Contents

- Item 1. Throttle Balance - Daytona 675 from VIN 564948 and Daytona 675R from VIN 564948
- Item 2. Camshafts - Tiger 800, Tiger 800 ABS and Tiger 800XC ABS

Description: Throttle Balance

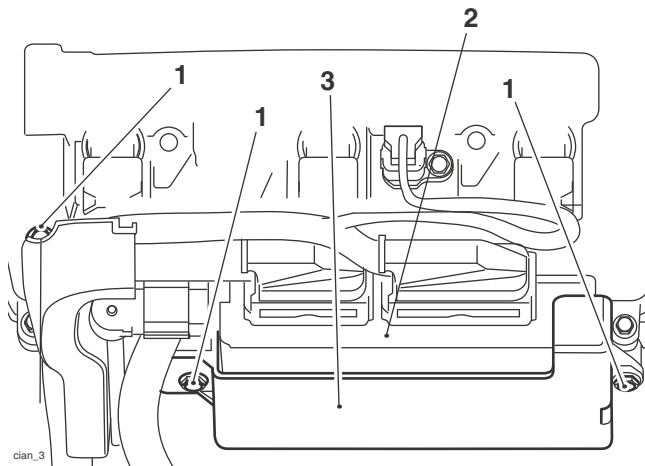
The throttle balance procedure described in the above models' Service Manuals is correct for the Street Triple and Street Triple R only.

For the correct method of throttle balance for the above models, carry out the following procedure.

Description: Camshafts

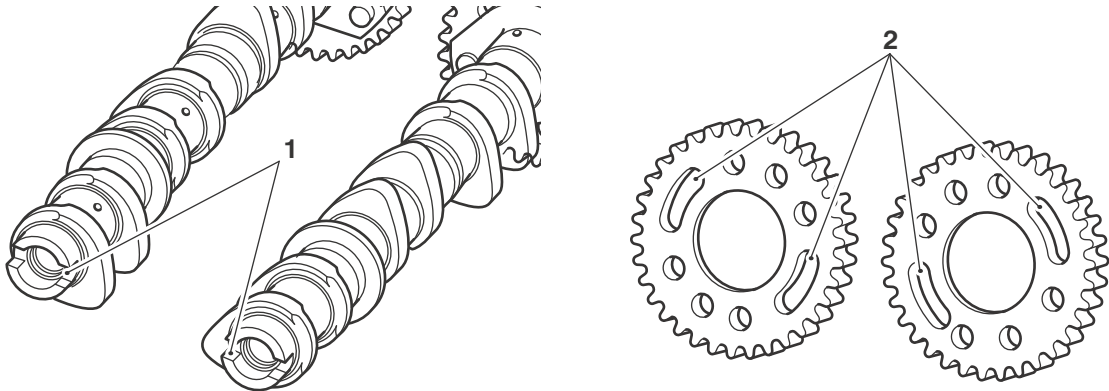
New camshafts have been introduced to the above models from engine number 602078 and are not retrofittable.

The difference between the original and new camshafts are as follows:

- The camshaft end, opposite the sprocket, has a slot which is used for timing.
- The sprocket for the new camshaft has elongated holes for timing.
- The crankcase has a hole for the timing pin.
- The crankshaft has a hole for the timing pin.

The removal, installation and timing of the new camshafts is different to that described in Service Manual, see Removal - Camshaft on page [4](#).

Description: Clutch and Brake Lever Pivot Pins

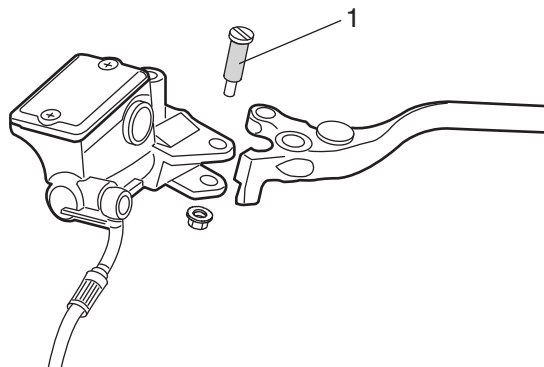
When refitting the clutch or brake lever pivot pins on the above models, apply a smear of silicone grease to the shank of the pivot pin.

Item 4.**Description:** Centre Stand Up Stop Rubber**Models affected:** Trophy, Trophy SE, Tiger Explorer and Tiger Explorer XC

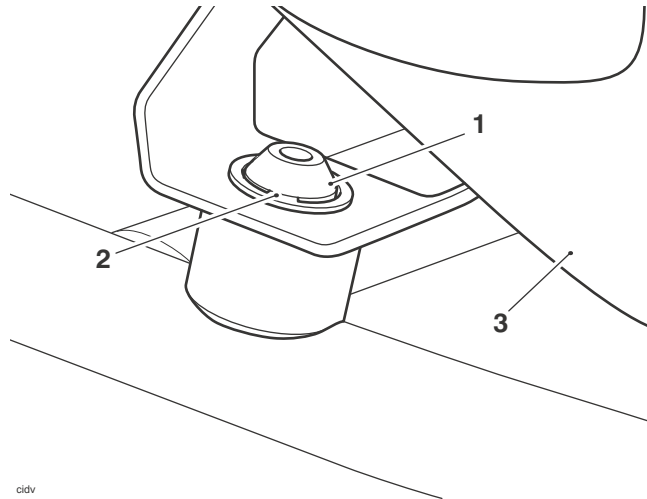
On some of the above models, an E-clip is used to secure the up stop rubber to its mounting.

If fitting a new up stop rubber, ensure an E-clip is fitted to secure the up stop rubber as shown in the illustration below.

For models that did not have an E-clip fitted to the original up stop rubber, refer to the EPC for the part number and fit a new E-clip.

Description: Rear Subframe Lower Fixings

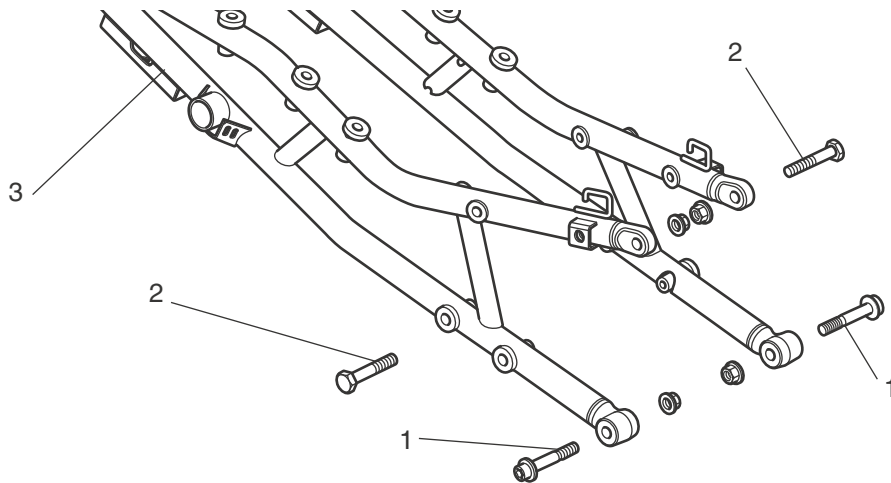
The torque figure for the lower fixings on the rear subframe has changed to **60 Nm** on the above model.

The lower and upper fixings for the rear subframe now have the same torque figure of **60 Nm**.

Description: Support Bracket, Rear Body Panel

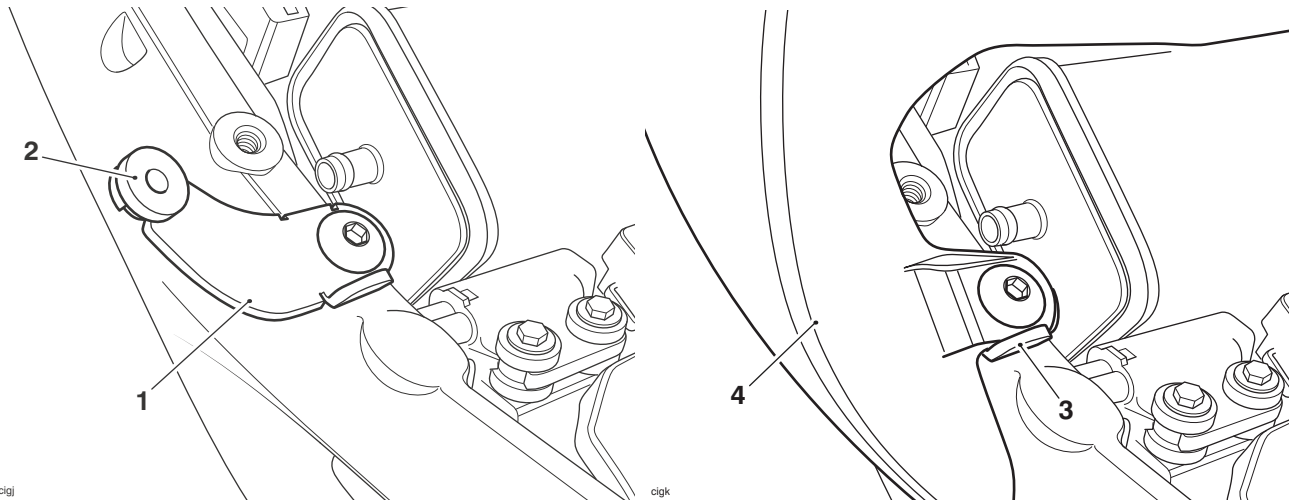
A support bracket and rubber foot assembly has been introduced to the front of the rear body panels on the above models from VIN 601623. The bracket is positioned between the rear panel and the rear subframe and its orientation is as shown in the illustration below.

The torque figure for the fixing remains at **3 Nm**.

Description: Brake Line Unions to ABS Modulator

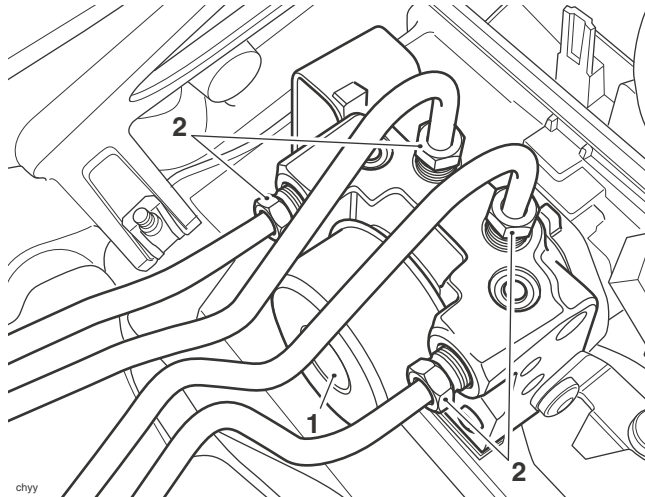
The torque figure for the brake line unions to the ABS modulator have changed to **15 Nm** on the above models.

Description: Front Brake Hose Fixing

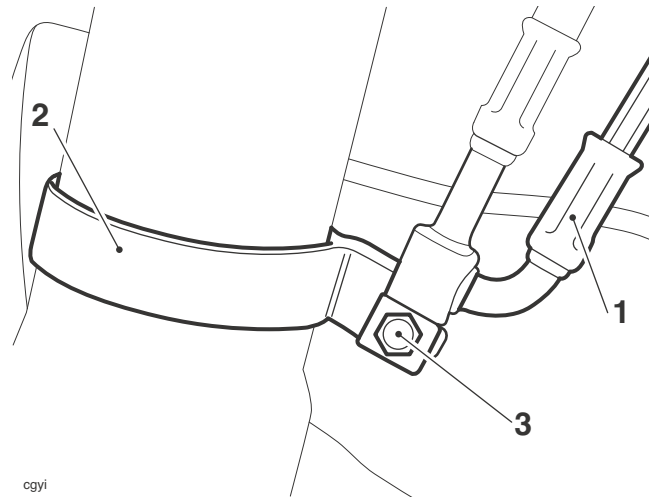
The torque figure for the fixing securing the front brake hose to its clip on the front fork has changed to **4 Nm** on the above models.

Description: **Harness Guide Fixings**

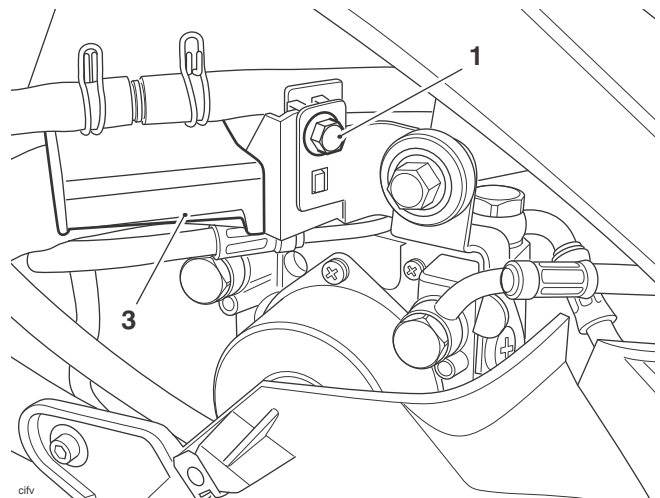
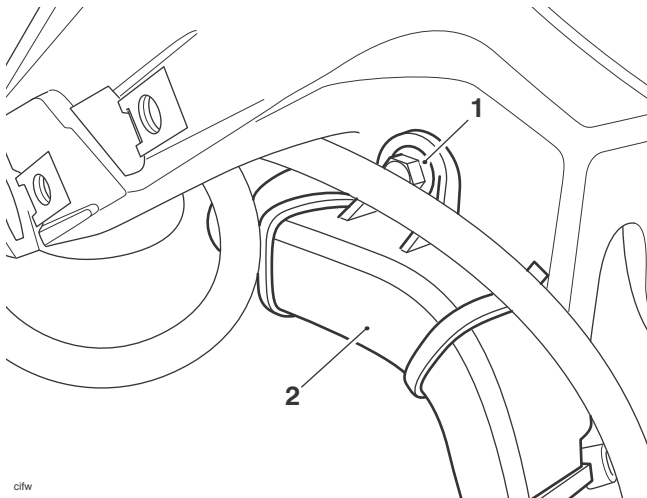
The torque figure for the fixings securing the front right hand harness guide to front subframe and the centre harness guide near the ABS modulator has changed to **3 Nm** on the above models.

Description: Selector Fork Shaft

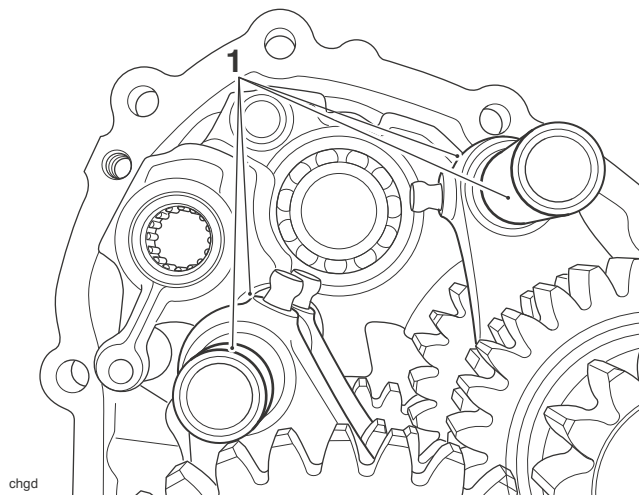
If the transmission is rebuilt for any reason, each end of the selector shafts must be coated with a 50/50 solution of engine oil and molybdenum disulphide grease as shown below.

Description: Breather Cover Tightening Sequence

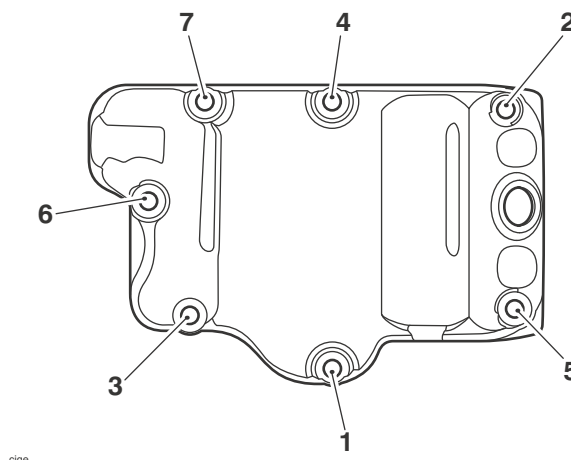
A tightening sequence for the engine breather cover has been introduced on the above models.

Tighten the new fixings to **11 Nm** in the sequence shown below.

Description: **Secondary Air Injection to Airbox Hose Spring Clip**

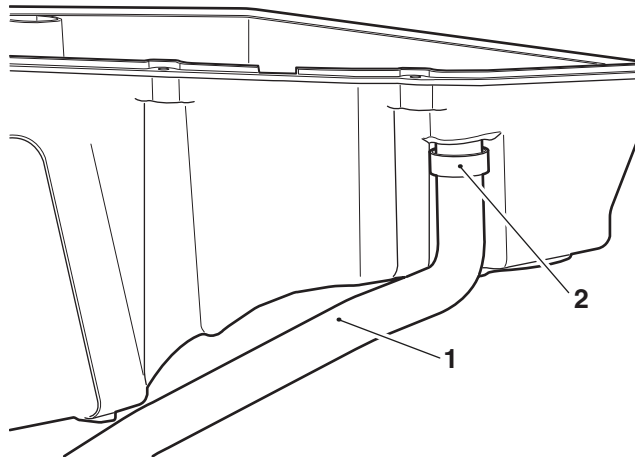
The spring clip securing the secondary air injection hose to the airbox has been removed on the above models from VIN 587665.

Description: **Front Fork Protectors and their Fixings**

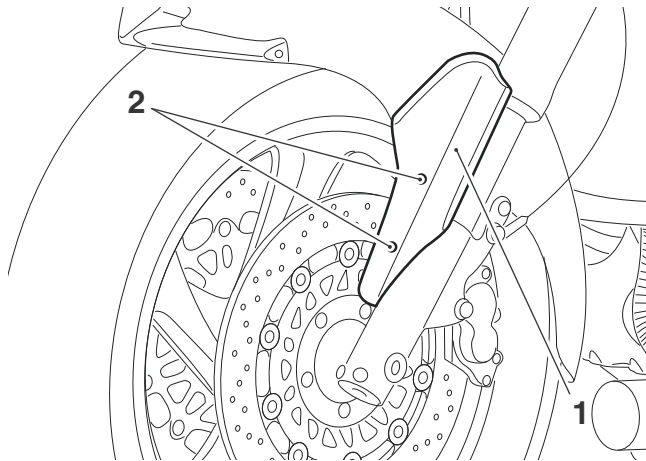
New front fork protectors and their fixings have been introduced to the above model from VIN 605701 and are retrofittable.

The only visual difference between the original and latest condition fork protectors is the powder coat finish around the fixings area. Because of this finish, encapsulated fixings are used to secure the protectors to the front forks.

If replacing the front fork protectors up to VIN 605700, encapsulated fixings must be used to secure the front fork protectors. To facilitate this a parts kit, part number T2045817 is available. The parts kit consists of:

Description: Clutch Assembly

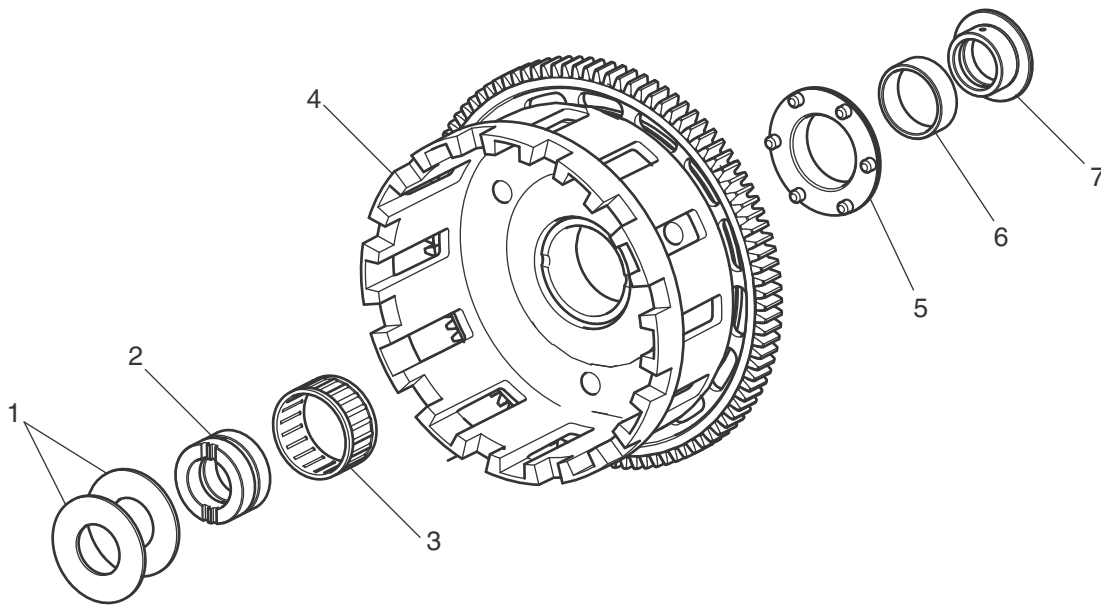
In order to ensure the correct end float of the clutch assembly, shims may be fitted between the clutch's bearing sleeve and thrust washer on the above models from engine number 600339.

To ensure the correct end float, the parts kit T1170460 must fitted if one or more of the following items is to be replaced in service:

Each parts kit is assembled to an input shaft at the factory and the end float is measured. Depending on the measurement zero to six shims will be added to the parts kit.
